**Calculation Change Notice 2007-0034 for DA-EE-92-098-01
“Diesel Generator A Steady State Loading Analysis”**

ATTACHMENT 2, CALCULATION CHANGE NOTICE (CCN) COVERSHEET

Diesel Generator A Steady State Loading Analysis

DA-EE-92-098-01

Figure 3 - EDGA Frequency (Hz) during 1996 RSSP2.2

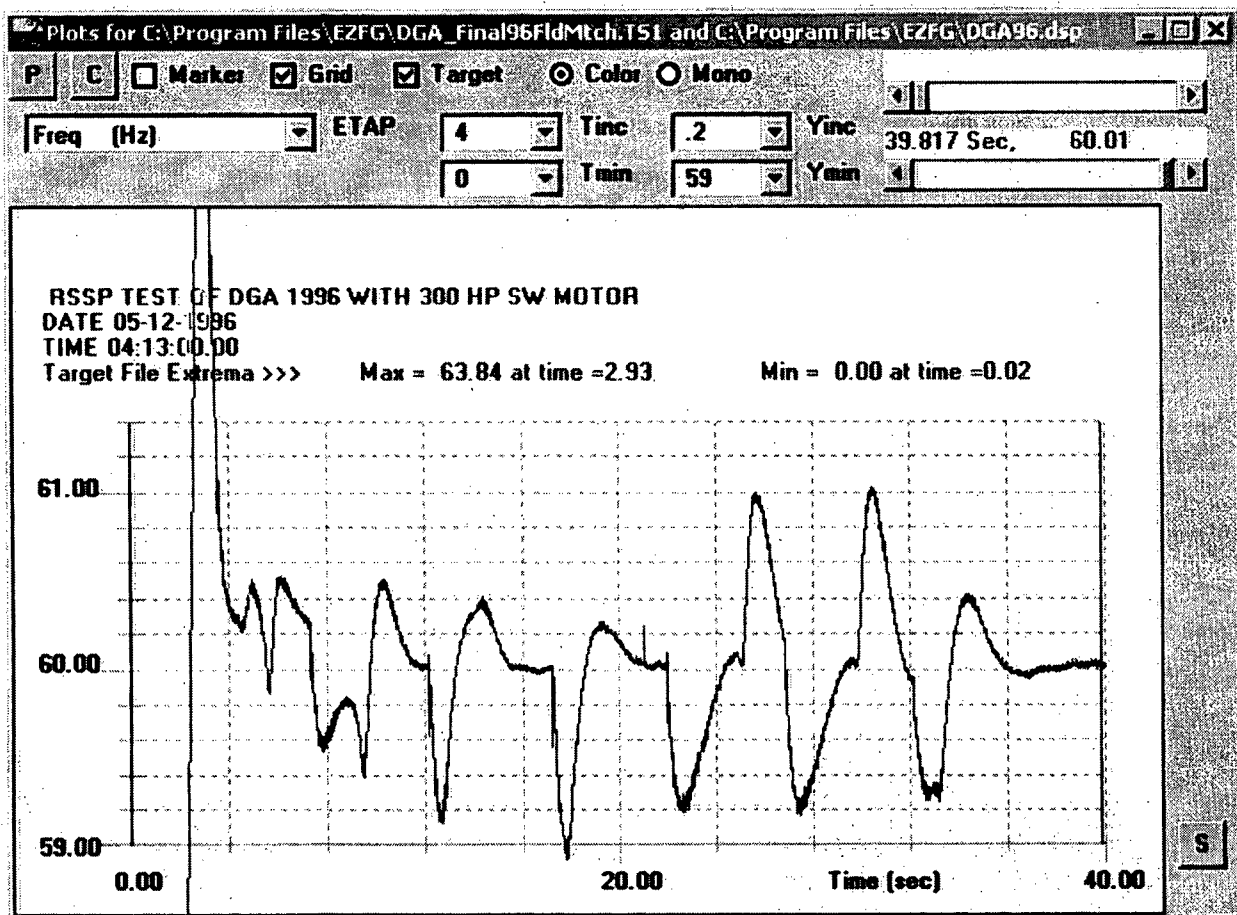
Insert

60.8

HOWEVER A FREQUENCY RANGE BETWEEN 59.5 HZ AND 60.5 HZ WILL BE USED.
